Access Compliance Report

Public Rights-of-Way

Intersection ID: 29928	Main Street: BEARD_RD	Cross Street: CAROLINA_LILY_LN	Location: NE
ADA ID: E0F4D06EFBA3	Ramp Type: BlendTrans1	Initial Pass/Fail: Fail	Overall Compliance: No
		Severity Score: 1.25

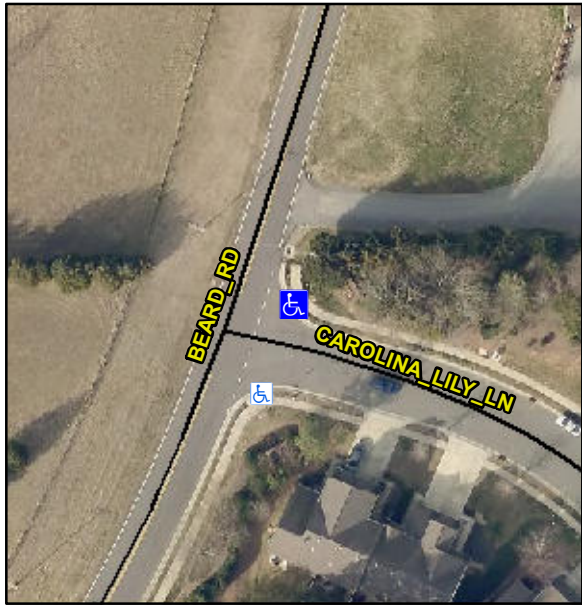
Codes/Mitigation Info/Possible Solution			Field Measurements/Component Compliance					
	Possible Solutions:		Compliance	Description	Data	Compliance	Description	Data
	Remove & Replace Curb Ramp With Two New Directional Ramps or Equivalent.		N/A	Ramp Length (in)	38.0	Yes	BlendTrans Slope (%)	4.4
			Yes	Ramp Width (in)	48.0	No	BlendTrans XSlope (%)	3.8
			N/A	Flare Type LT	N/A	N/A	Flare Type RT	N/A
			N/A	Flare Slope LT (%)	N/A	N/A	Flare Slope RT (%)	N/A
			N/A	Flare Traversable LT?	N/A	N/A	Flare Traversable RT?	N/A
			N/A	Landing Length (in)	N/A	N/A	DWS Provided?	N/A
			N/A	Landing Width (in)	N/A	N/A	DWS Contrast?	N/A
			N/A	Landing Slope (%)	N/A	N/A	DWS Length (in)	N/A
			N/A	Landing X Slope (%)	N/A	N/A	DWS Full Width?	N/A
			N/A	Landing Curb? (Y/N)	N/A	N/A	DWS Offset (in)	N/A
			N/A	Shared Landing?	N/A			
			N/A	Gutter Ponding?	N/A	N/A	Gutter Slope (%)	N/A
			N/A	Gutter Lip Ht (in)	N/A	N/A	Gutter X Slope (%)	N/A
